December 4, 2025

Re: BZA Case No. 21361 – 1253 Morse St NE Applicant: Mashood Olayinka
Parties: Natalie Martinez and Andrew Karay

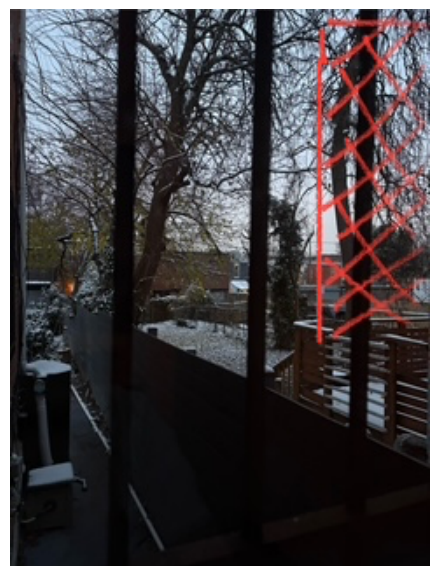
Both the November 18 filing and the December 5 response claim that our home “would not view or be impacted by the construction.” This is factually incorrect. Our second-floor bedroom windows directly

face the property line, with a clear sightline to the area where the extension would be constructed. Photographs included with this statement show this plainly.
